June 24, 2015

**SUBJECT: 2.206 Petition on Current Licensing Basis for Flooding at Pilgrim**

**Pilgrim's Flood Hazard Re-Evaluation**

Figure 1: Table 4-1 from Pilgrim’s Flood Hazard Re-Evaluation Report

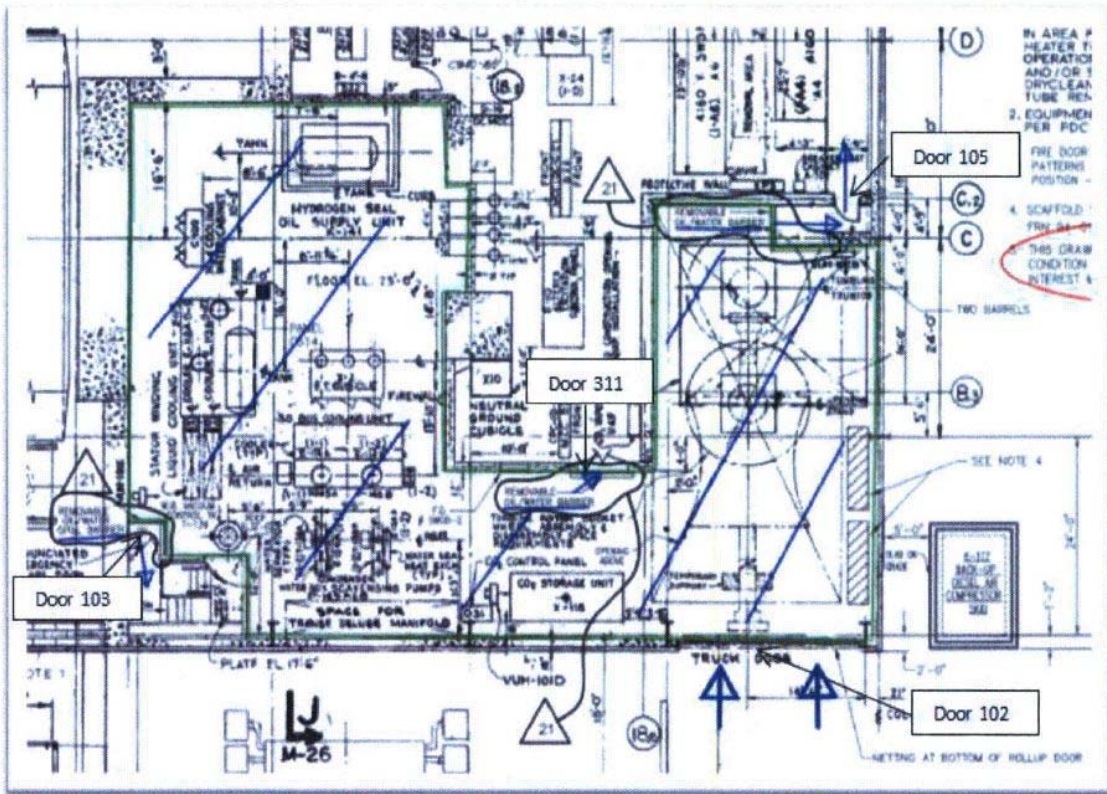
Table 4-1 in Pilgrim's flood hazard re-evaluation report is replicated as Figure 1 in this petition. It shows that the extreme storm surge event was re-evaluated to have a maximum height of 15.8 MSL, providing more than 7 feet (about 50 percent) margin to the 23 feet MSL minimum entrance elevation for areas housing structures, systems and components important to safety.

Table 4-1 also shows that local intense precipitation events can result in flooding up to 23.5 feet MSL "at important locations on north and west sides of plant" and up to 25.2 feet MSL "at important locations on south side of plant." Such events have negative margin to the 23 feet MSL minimum entrance elevation.

As Figure 1 in this petition (Table 4-1 from Pilgrim's flood hazard re-evaluation report) clearly indicates, the heavy rainfall events constitute a significantly greater flooding hazard at Pilgrim than that posed by an extreme storm surge. Heavy rainfall events could result in flooding levels above the entrance elevations to areas housing structures, systems and components important to safety whereas the maximum extreme storm surge flooding levels are several feet below that elevation. Consequently, administrative measures protecting against damage from extreme storm surges do not also protect against damage from heavy rainfall events.

The petitioners ask the NRC to take enforcement action that results in heavy rainfall events being included in the current licensing basis for the Pilgrim Nuclear Power Station. Granting this petition puts no undue burden on the plant's owner and removes an undue burden from the public.
